IN THE MATTER OF: )  
)  
LDEQ Title V Air Operating Permit )  
No. 1680-00097-V3 )  
) Permit No. 1680-00097-V3  
For LaSalle BioEnergy, LLC )  
)  
Issued by the Louisiana Department of )  
Environmental Quality )

**PETITION TO OBJECT TO THE TITLE V OPERATING PERMIT FOR  
LASALLE BIOENERGY’S URANIA, LOUISIANA WOOD PELLET MILL**

Figure 1: VOC emission factors from stack tests applied to the production rate of 578,000 tpy, which is the nameplate capacity of the existing Drax LaSalle Plant. The red line is the combined BACT limits for each of the two pellet coolers.

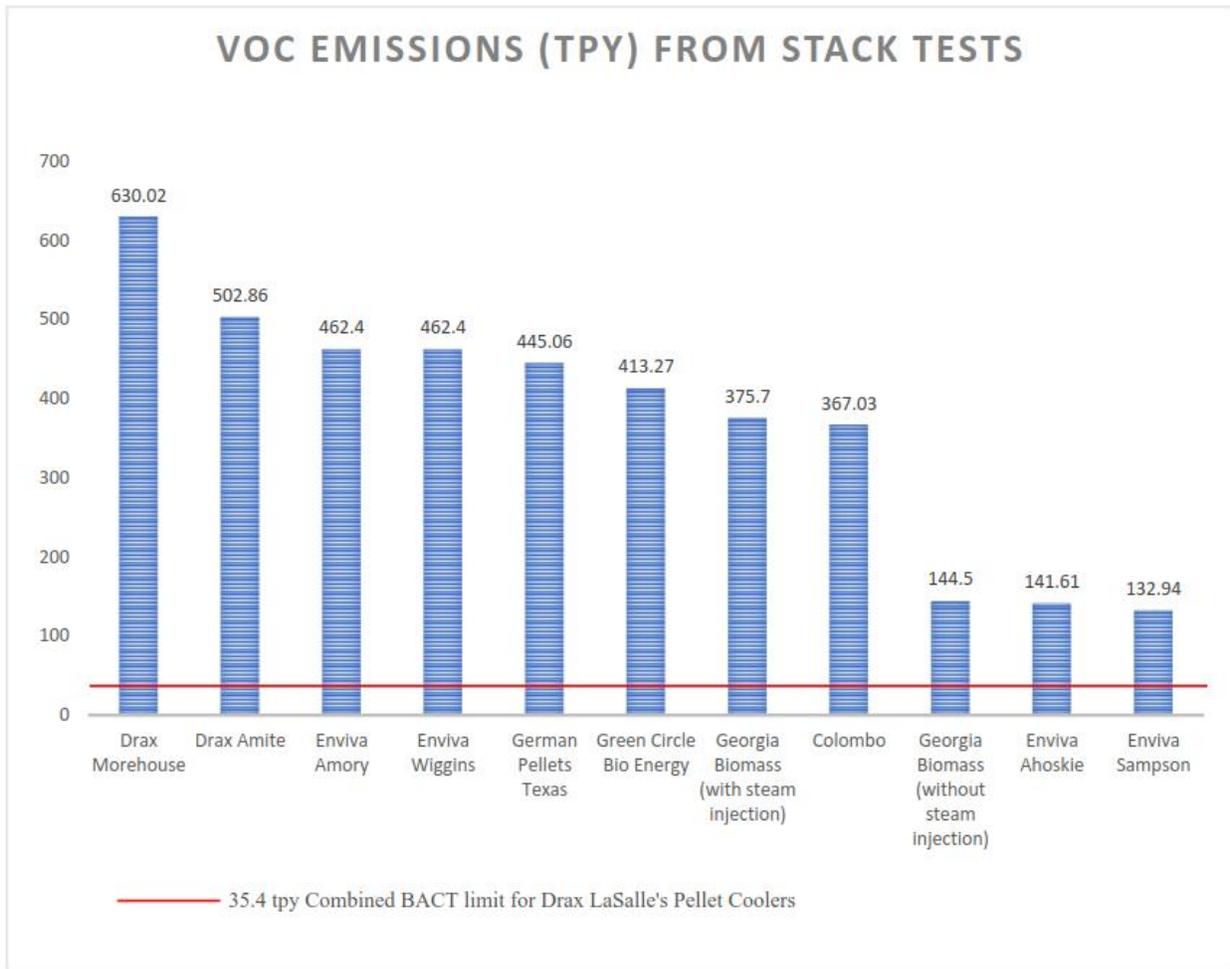
As this graph shows, the combined BACT limits of 17.7 tpy for each of the two pellet cooler outlets, i.e. 35.4 tpy total, is simply unattainable for Drax LaSalle if it operates anywhere near its nameplate capacity of 578,000 tpy. The table below provides the same information, along with the softwood percentage processed during the test. Processing more softwood increases VOC emissions,<sup>21</sup> therefore tests like Enviva Ahoskie (35% softwood) and Enviva Sampson (52% softwood) at lower softwood percentages likely underestimate Drax’s emissions, given the fact that Drax LaSalle processes close to 100% softwood.<sup>22</sup>

In short, there is not a single test in this industry that supports the idea that Drax LaSalle can comply with the permit’s pellet cooler BACT limits at its permitted production rate of 578,000 tpy. To the contrary, based on the average emission factor from the 11 available stack tests (including even the unrepresentative tests such as Enviva Ahoskie, processing just 34% softwood), the plant would need to produce pellets at a rate of less than 55,000 tpy—about 10% of the facility’s nameplate capacity—in order to comply with the BACT limits.
